ADDENDUM #2

**PROJECT: PUBLIC SAFETY COMPLEX H2 BUILDING RENOVATIONS FOR VETERAN'S AFFAIRS
CITY PARISH PROJECT NO. 21-ASC-CP-1558**

**ADDENDUM NO. 2
10/30/2024**

**PUBLIC SAFETY COMPLEX H2 BUILDING
RENOVATION FOR VETERAN'S AFFAIRS
9050 AIRLINE HWY. STE. 120,
BATON ROUGE, LOUISIANA 70815
CITY PARISH PROJECT NO. 21-ASC-CP-1558**

A1 DEMOLITION PLAN - VETERANS AFFAIRS
SCALE: 1/4" = 1'-0"
RE:

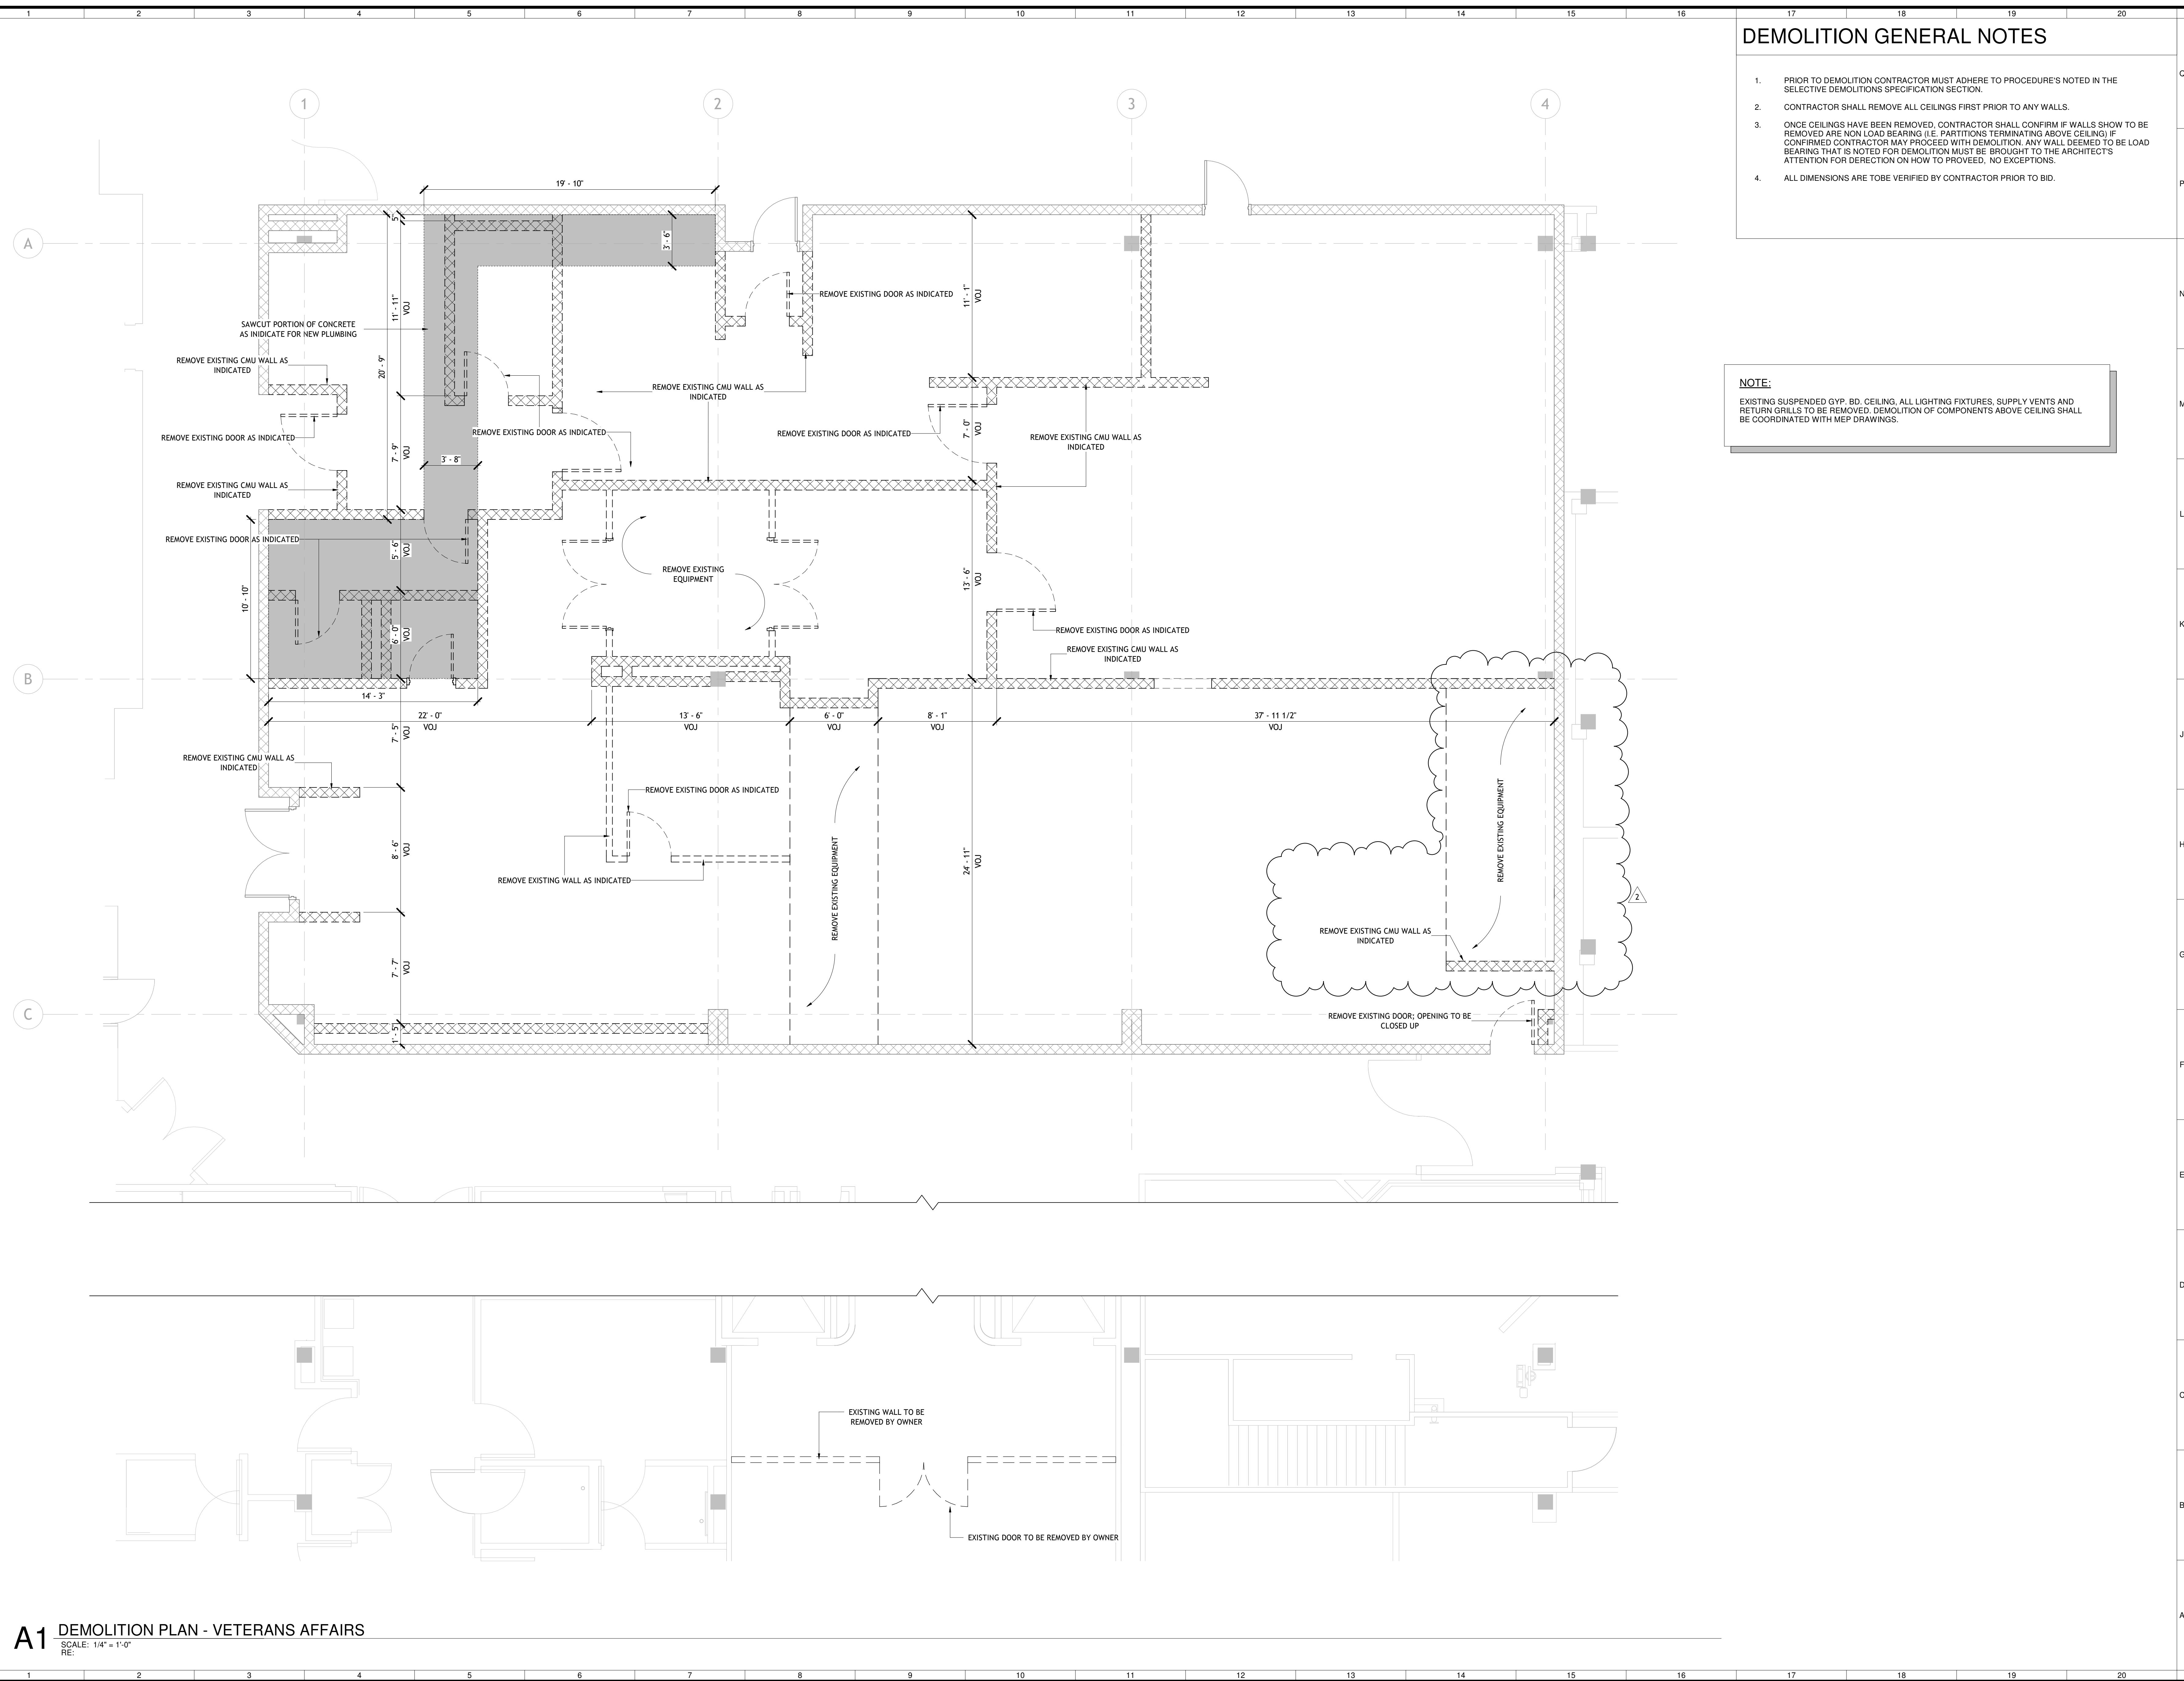
1. **Sheet D-100**, shaded area of concrete that is to be removed for new plumbing shall be infilled with the following:
 - a. 4" thick 3500 psi Concrete over 15 mil Polyethylene Vapor Barrier. Include WWF 4 Gauge, 4" x 4" W4.0 x W4.0 and pin all sides of new concrete to existing concrete with #5 smooth dowels 16" long, drilled into the existing concrete 8", grease the end being set into the exiting concrete to allow for movement. Fill excavation with 610 limestone as required for 4" concrete to flush out with the existing concrete. For bid purposes, contractor shall assume a 24" depth of fill below the new slab for the plan area indicated.

SHEET NO.
A-100
of

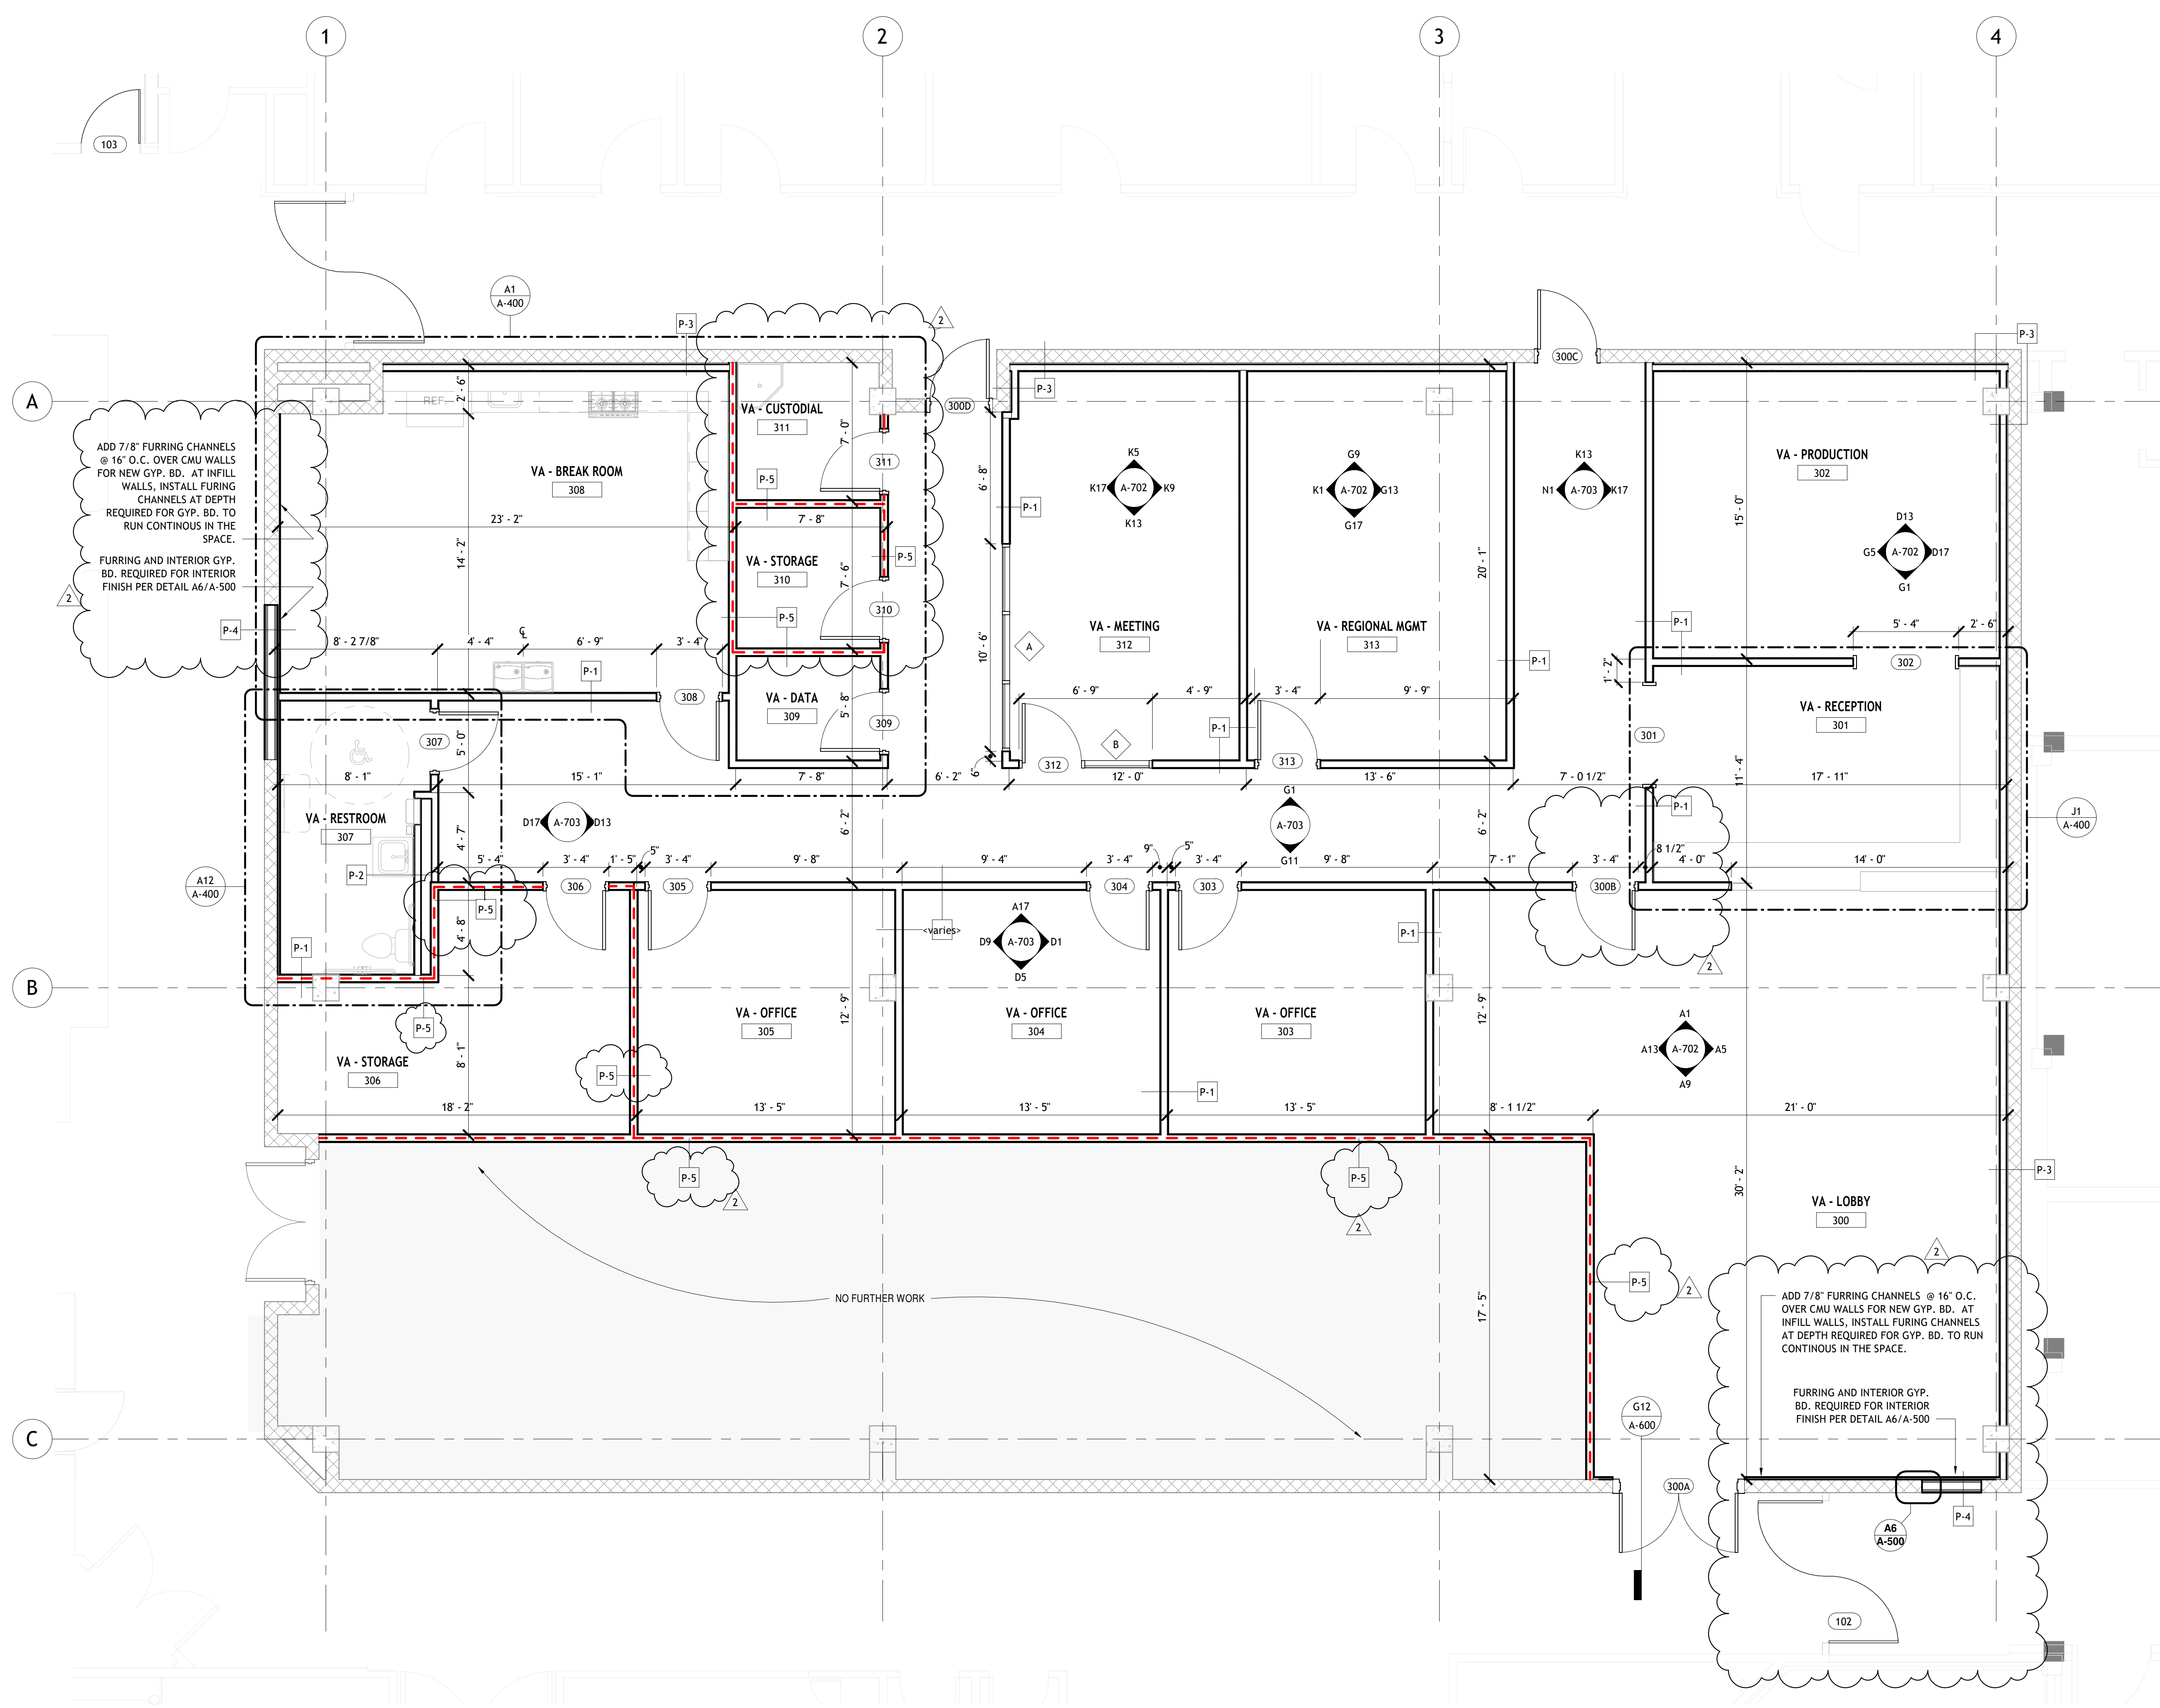
3. **Sheet A-100**, remove sheet A-100 and replace with the attached sheet A-100
 - a. Clarifications include
 - i. P-5 partition type
 - ii. P-4 partition type with notes for adjacent interior spaces

- iii. Door 102 double egress door is identified
 - iv. Flip door swing on 300B
4. **Sheet A-410**, remove sheet A410 and replace with the attached sheet A-410

A1 PARTITION TYPES
SCALE: 1" = 1'-0"
RE:

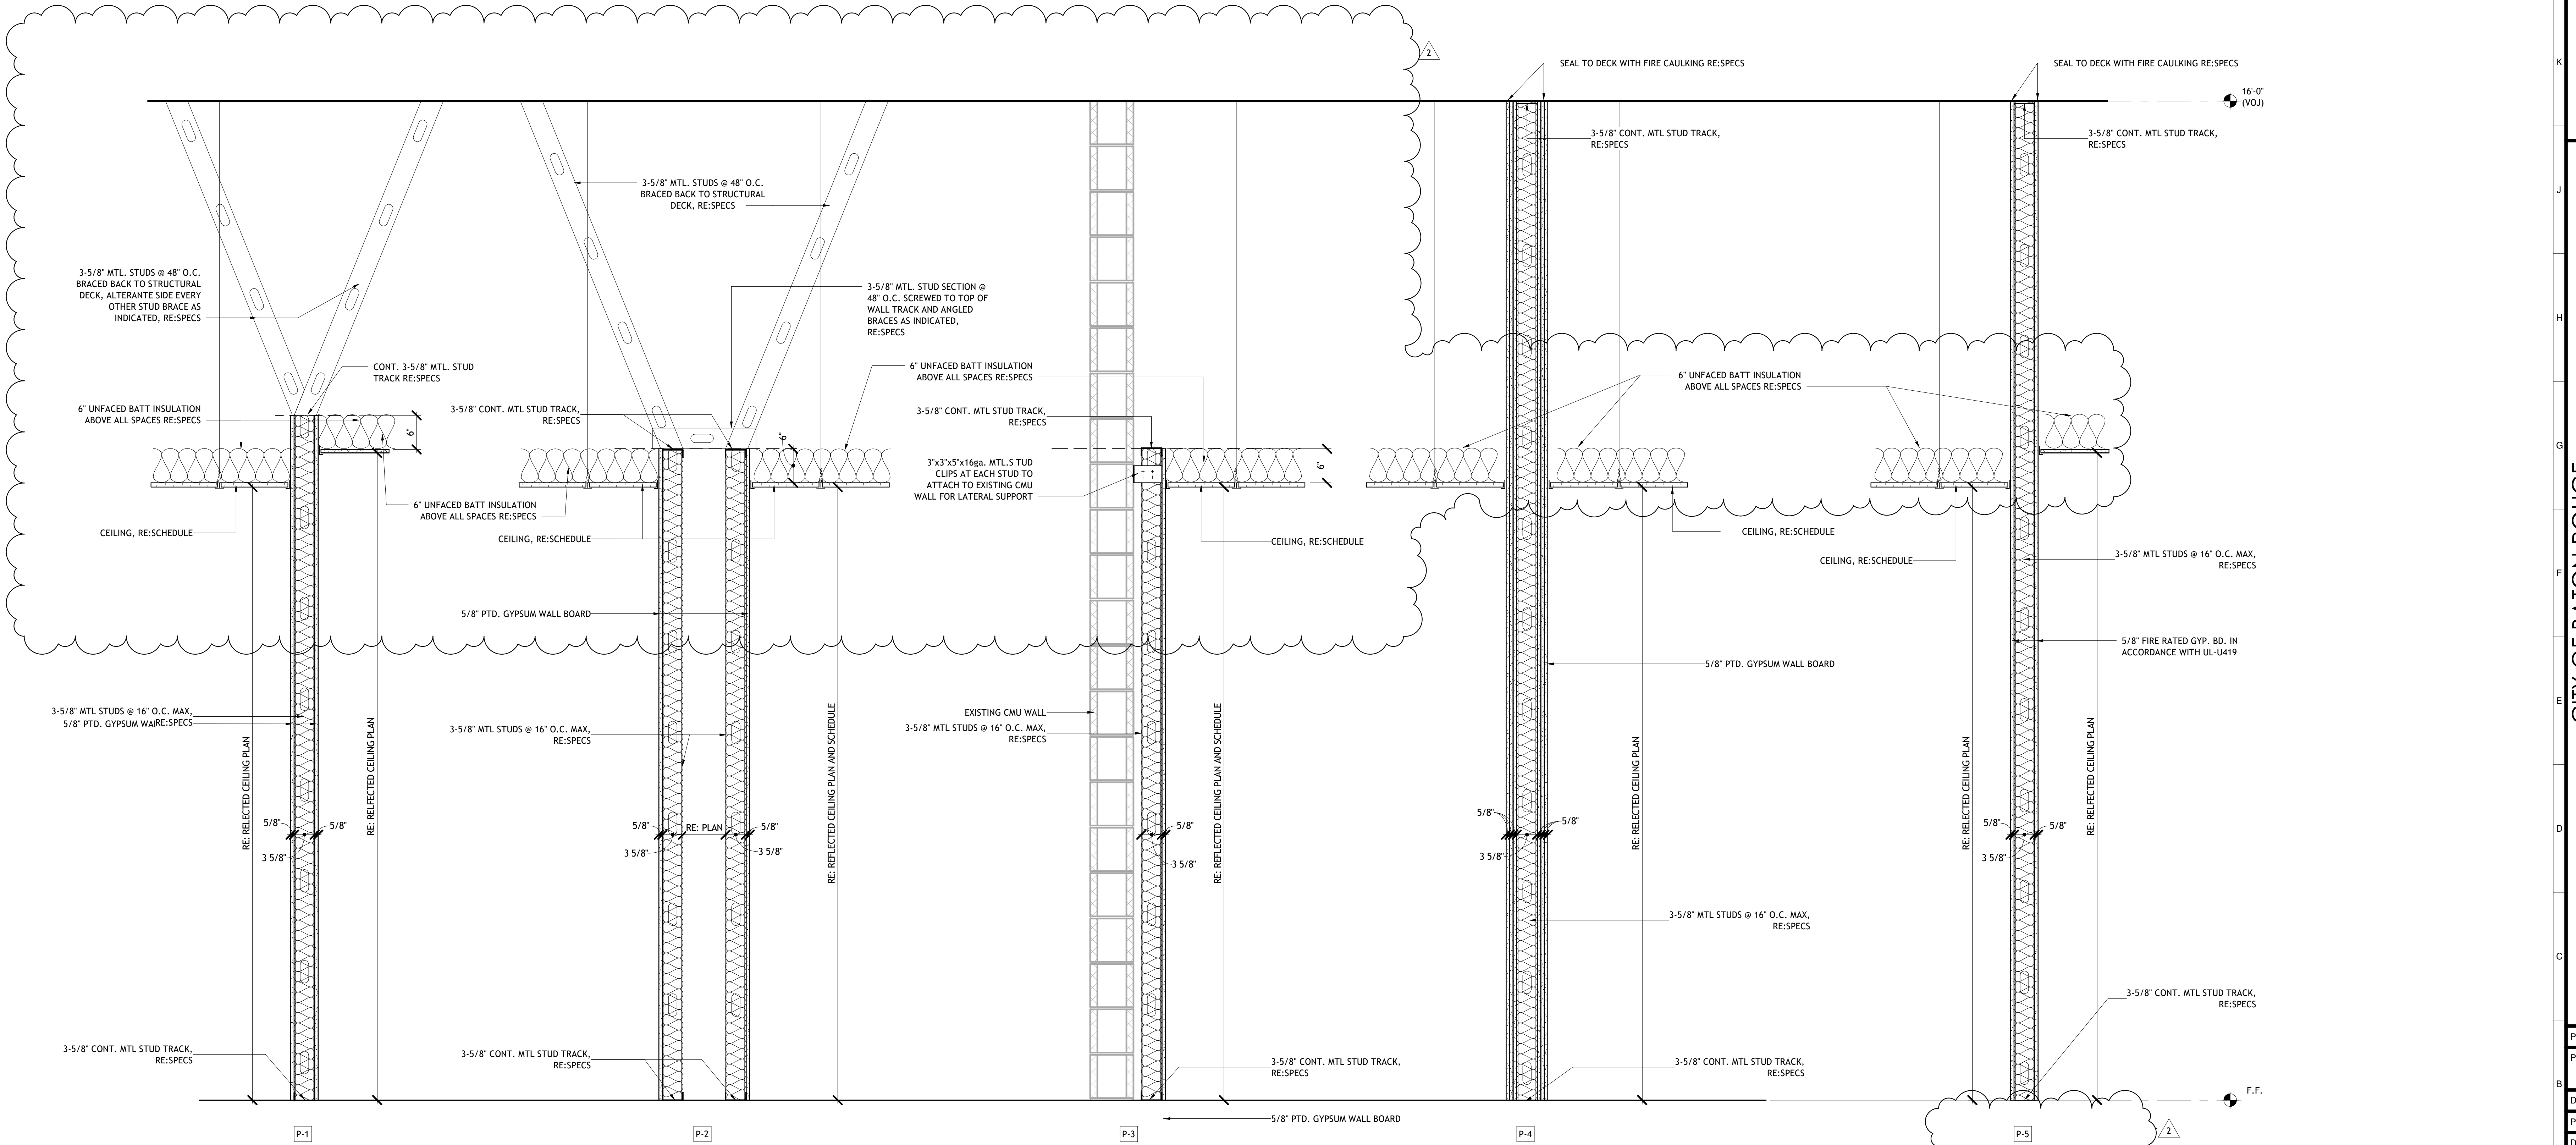
2. **Sheet A-500**, Detail A6 is intended for infill walls separating the Veterans Affairs Tenant space from the existing corridors. The infill partition is a U419 3hr partition, all joints must be sealed to the existing walls with the appropriate sealant detail as required by the fire joint sealant manufacturer. Furring channels and an additional layer of gypsum board are required within the Veterans affairs tenant space to provide a continuous and clean surface within the new tenant space.
